<b>Title - Sujet</b> Water Tank Install on Truck Chassis	
<b>Solicitation No. - N° de l'invitation</b> W8476-185810/B	<b>Amendment No. - N° modif.</b> 002
<b>Client Reference No. - N° de référence du client</b> 6000419886	<b>Date</b> 2018-07-24
<b>GETS Reference No. - N° de référence de SEAG</b> PW-\$\$HP-930-75000	
<b>File No. - N° de dossier</b> hp930.W8476-185810	<b>CCC No./N° CCC - FMS No./N° VME</b>
<b>Solicitation Closes - L'invitation prend fin</b> <b>at - à 02:00 PM</b> <b>on - le 2018-08-08</b>	<b>Time Zone</b> <b>Fuseau horaire</b> Eastern Daylight Saving Time EDT
<b>F.O.B. - F.A.B.</b> <b>Plant-Usine:</b> <input type="checkbox"/> <b>Destination:</b> <input checked="" type="checkbox"/> <b>Other-Autre:</b> <input type="checkbox"/>	
<b>Address Enquiries to: - Adresser toutes questions à:</b> D'Allaire, Yvonne	<b>Buyer Id - Id de l'acheteur</b> hp930
<b>Telephone No. - N° de téléphone</b> (873) 469-3359 ( )	<b>FAX No. - N° de FAX</b> ( ) -

## AMENDMENT 002

This solicitation amendment is raised to respond to bidders' questions and to amend Annex B – Purchase Description for Water Tank and Delivery System On a 4X4 Truck Chassis.

Government Supplied Equipment  
Matériel fourni par le gouvernement

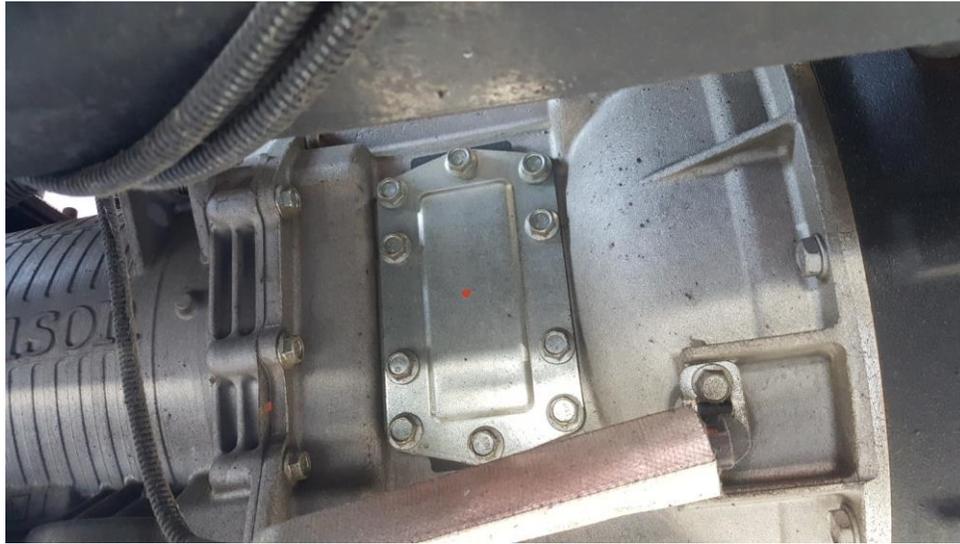
Please confirm that this diesel powered pump will be independently powered by the pump's own diesel engine and not by the truck's diesel engine via PTO.

The Purchase Description has been modified so that the proposals can be submitted with a pump design that is powered by an independent diesel engine or make use of the PTO provision available on the furnished truck chassis.

a) If the pump is driven by an independent engine:

- i. The engine **must** be diesel powered.
- ii. The engine **must** be provided with an electrical starting system.

b) If the pump is driven by the PTO provisions on the government furnished equipment:

- i. The product-pumping system **must** either be driven directly by PTO shafts or by a hydraulic motor.
- ii. The PTO shaft **must** be shielded or equipped with a guard for safety.
- iii. The PTO shaft **must** be a hot-shift type.
